Work Order ID 135129

Item Name: Fwd Crosstube - High 206 A/B

DART AEROSPACE LTD		Work Order:	135129
Description: Crosstube High Fwd (206B)		Part Number:	D206-667-101
Inspection Dwg: D206-667-141 Rev: C		Page 1 of 1

DRAWING NO. D206-667-141	TITLE CROSSTUBE ASS'Y (206B HIGH FWD)	REV. C	DART AEROSPACE LTD ENGINEERING ORDER		D.E.O. NO. D206-667-141-C-1	SHEET NO. SHEET 1 OF 1	SCALE NTS
DRAWN <i>97</i>	CHECKED <i>ASS</i>	MFG. APPR. <i>AD</i>	APPROVED <i>MD</i>		DE APPR. <i>HA</i>		
DATE 11.07.15	DATE 11.07.20	DATE 11.07.21	DATE 11/07/21		DATE 11.07.21

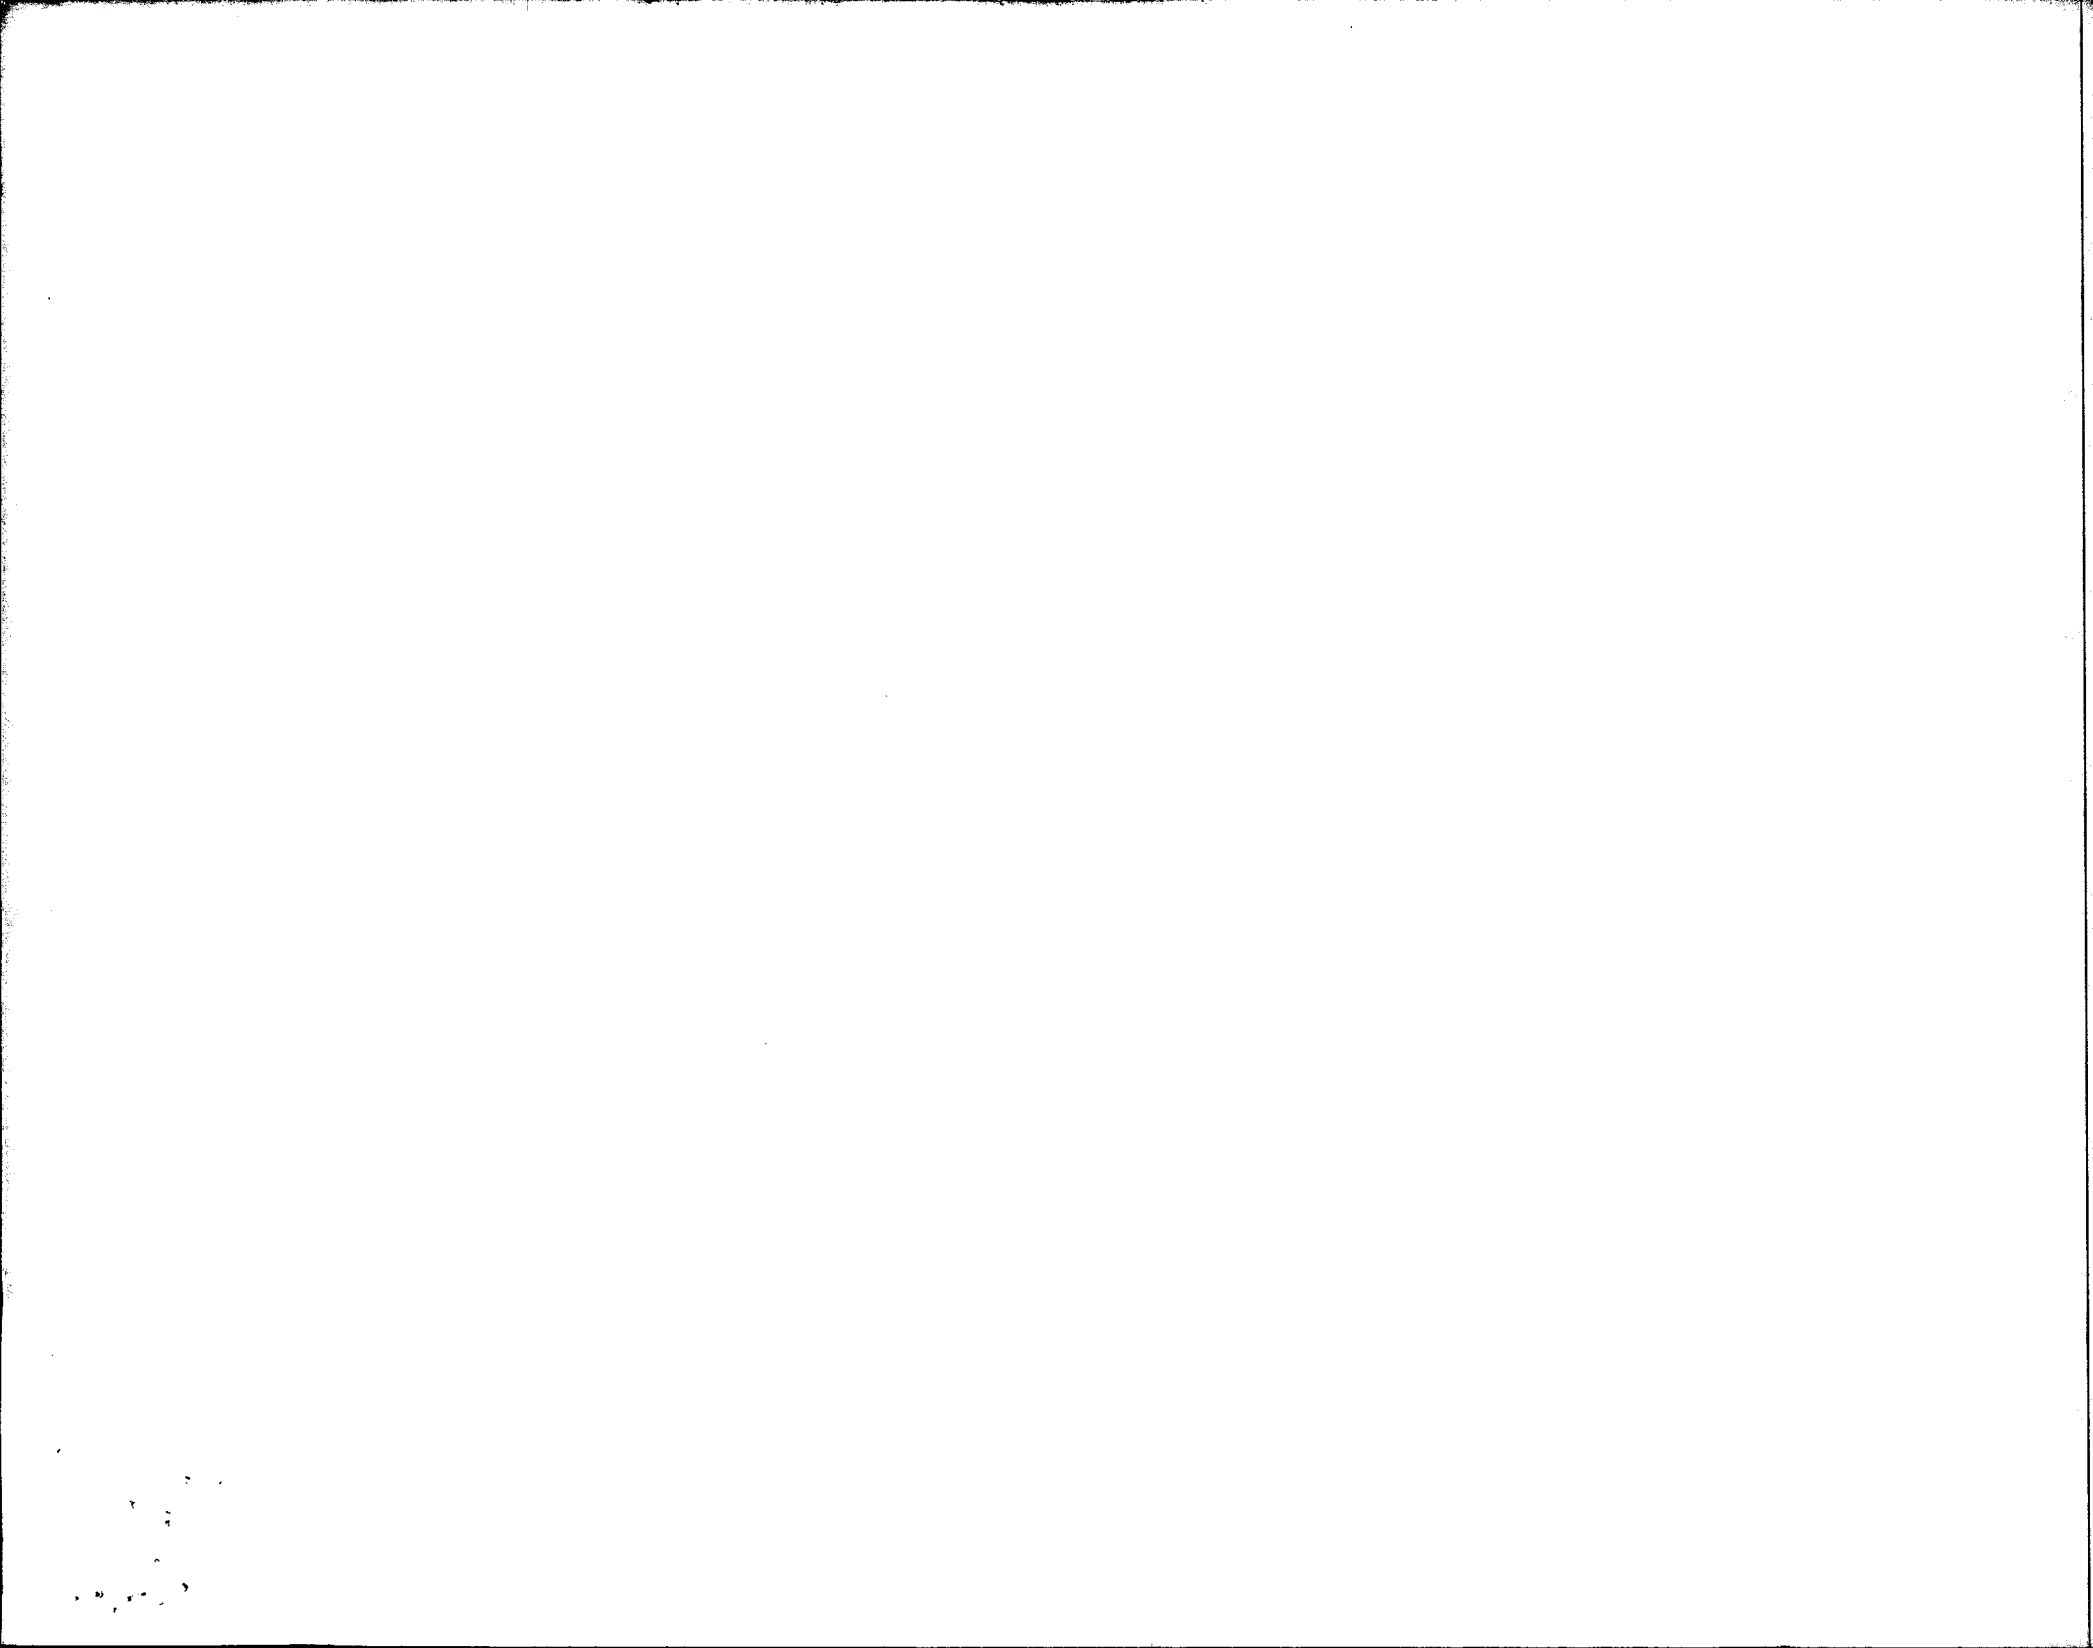
PURPOSE:

REPLACE MAGNOBOND WITH PROSEAL.

IS:

Item	Qty -141	Part Number	Description
9	A/R	PROSEAL 890 B-2	SEALANT, AMS-S-8802 CLASS B-2

WAS:

9	A/R	MAGNOBOND 6398	ROCKWELL SPECIFICATION RBO-120-023 ADHESIVE (TEXTRON/BELL SPEC. 299-947-100, TYPE II, CLASS 2 ADHESIVE)
---	-----	----------------	---

NOTE 12 & 15, SHEET 1 IS AMENDED AS FOLLOWS:

WAS:

- 12) INSTALL D2891-1 SUPPORT USING 0.03" TO 0.06" THICK LAYER OF MAGNOBOND 6398 PER QSI 015. LET CURE FOR 12 HOURS AFTER INSTALLATION AND PRIOR TO PACKAGING.
- 15) TORQUE CLAMPS 80 TO 100 IN-LB. ENSURE AT LEAST 1.5 THREADS SHOWING IN SAFETY AND THAT NUT HAS NOT BOTTOMED-OUT AFTER TORQUING.

IS:

- 12) TO INSTALL D2891-1 SUPPORT: ABRASE MATING SURFACE OF SUPPORT AND CROSSTUBE WITH 180-GRIT SANDPAPER AND REMOVE RESIDUE WITH MEK (OR EQUIVALENT). APPLY A 0.04" TO 0.07" THICK LAYER OF PROSEAL 890 CLASS B-2 (OR AMS-S-8802 CLASS B-2) SEALANT TO MATING SURFACE OF SUPPORT.
- 15) TORQUE CLAMPS 80 TO 100 IN-LB. ENSURE AT LEAST 1.5 THREADS SHOWING IN SAFETY AND THAT NUT HAS NOT BOTTOMED-OUT AFTER TORQUING. **PRIOR TO PACKAGING, RE-CHECK TORQUE ON CLAMPS AFTER PROSEAL 890 SEALANT HAS CURED FOR 72 HOURS.**

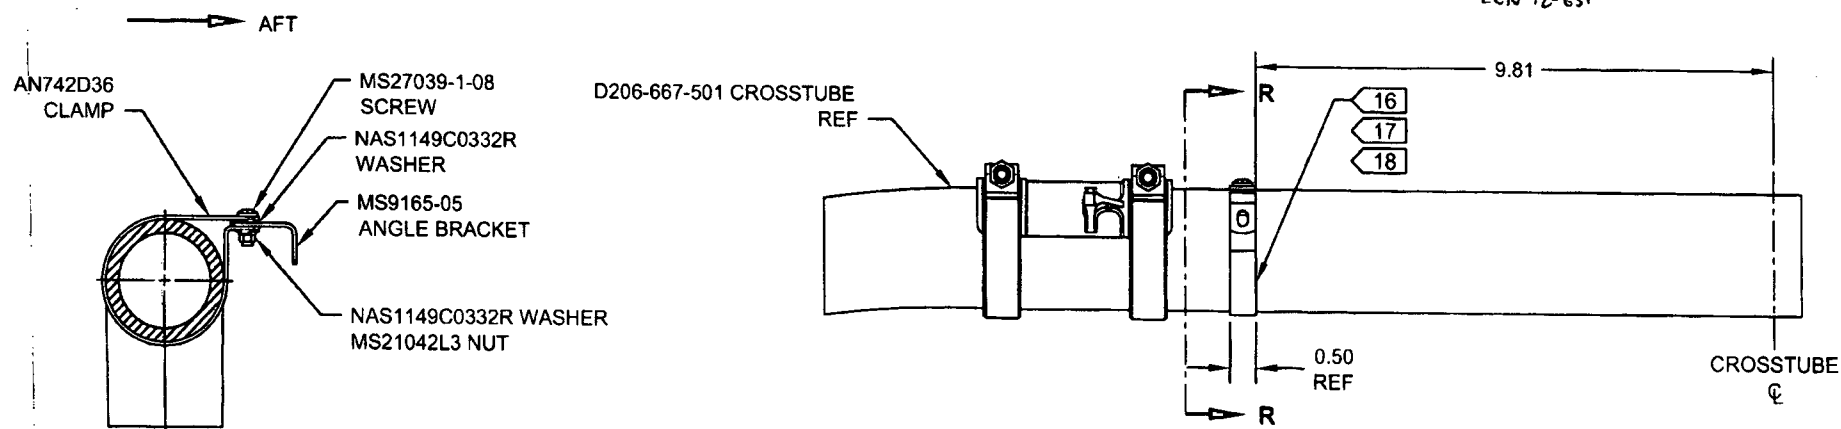
PURPOSE:

ADD ELECTRICAL GROUNDING STRAP

PARTS LIST:

ITEM	QTY -141	PART NUMBER	DESCRIPTION	
1	X	D206-667-141	CROSSTUBE ASSEMBLY (206B HIGH FWD)	
10	2	AN742D36	CLAMP	] ADD
11	2	MS9165-05	ANGLE BRACKET	
12	2	MS21042L3	NUT (OR MS21042-3)	
13	2	MS27039-1-08	SCREW	
14	4	NAS1149C0332R	WASHER (OR AN960C10L)

GENERAL NOTES:

- 16) MASK AREA UNDER CLAMP PRIOR TO PAINTING
17) SEAL EDGES WHERE AN742D36 CLAMP MEETS WITH THE CROSSTUBE USING SIKAFLEX-241/-291 OR MIL-S-8802 CLASS B2 OR PROSEAL 890 SEALANT
18) PERFORM RESISTANCE CHECK TO ENSURE MAX RESISTANCE IS 10 MILLIOHMS
